~~DI40~~  
DI40N10-06242004-2delinf3.doc

From: "R.O. Rushton" <rorushton@hopewelldesigns.com>  
To: "Eric Jameson" <EJameson@dnr.state.ga.us>  
Date: Thursday, 24 June, 2004 18:53:16  
Subject: Re: a couple of last questions on the DI40

From: "Eric Jameson" <EJameson@dnr.state.ga.us>  
To: <rorushton@hopewelldesigns.com>  
Sent: Thursday, June 24, 2004 11:09 AM  
Subject: a couple of last questions on the DI40

# Cross Section of Irradiator

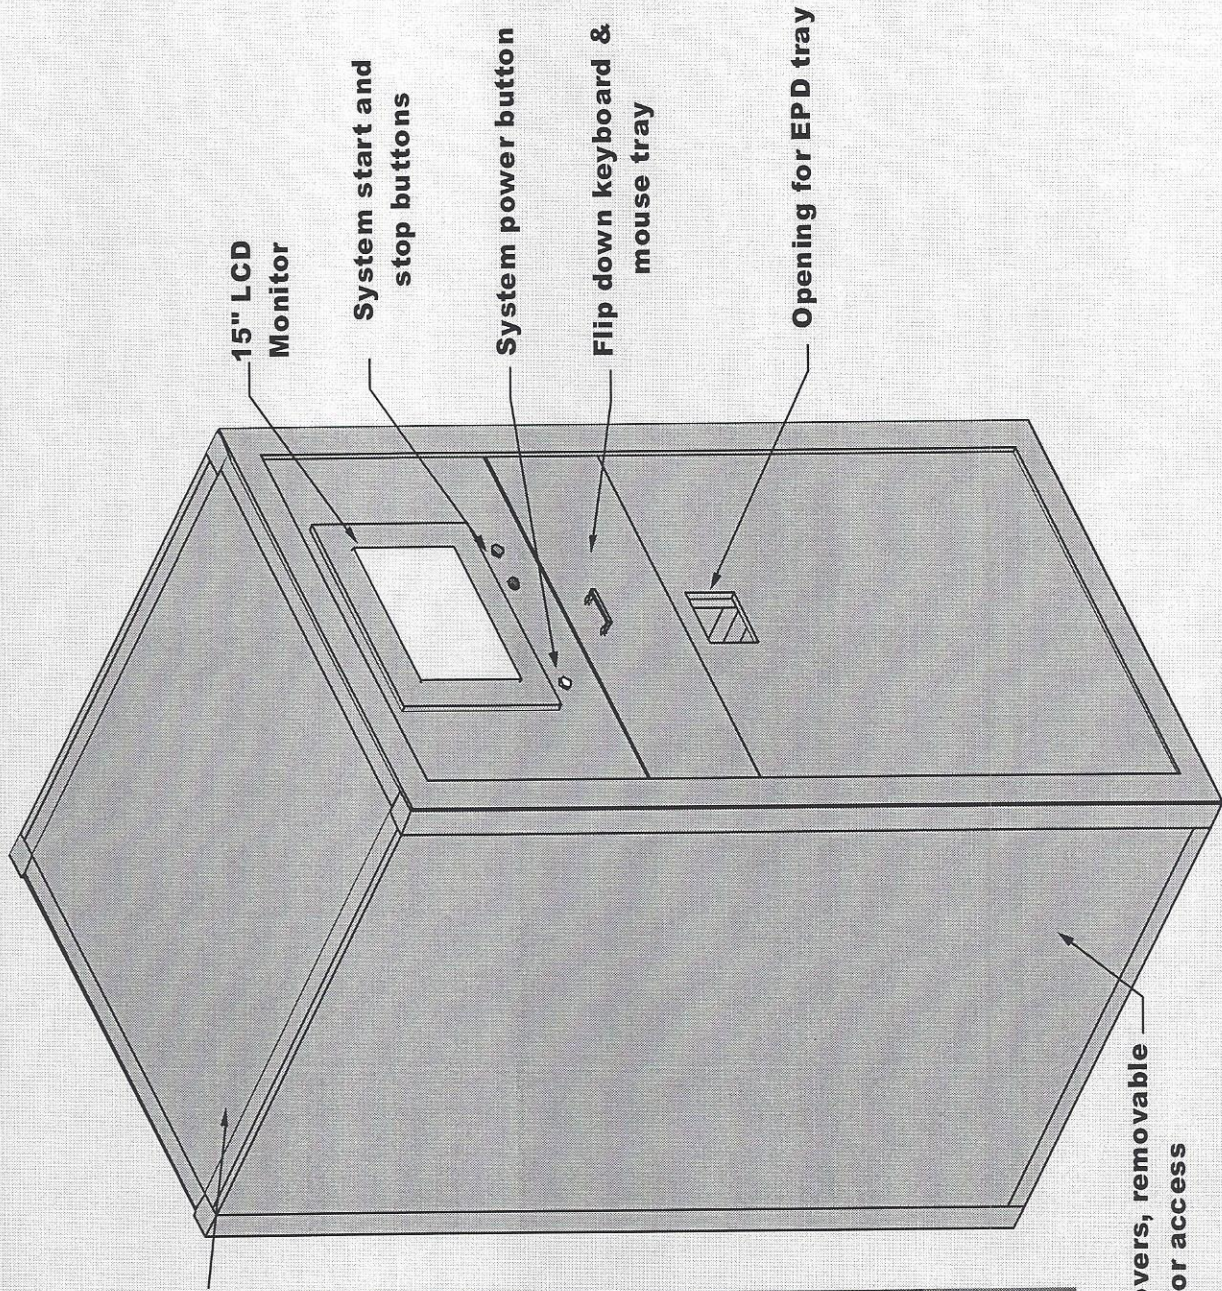
*Also, no information was listed that described the exterior paneling of the unit, that contains all the other components. This is useful to aid inspectors in identifying the unit visually.*

I have also attached a couple of slides from a Powerpoint presentation on the DI40 that shows the overall cabinet. This should give you an idea of what it looks like.
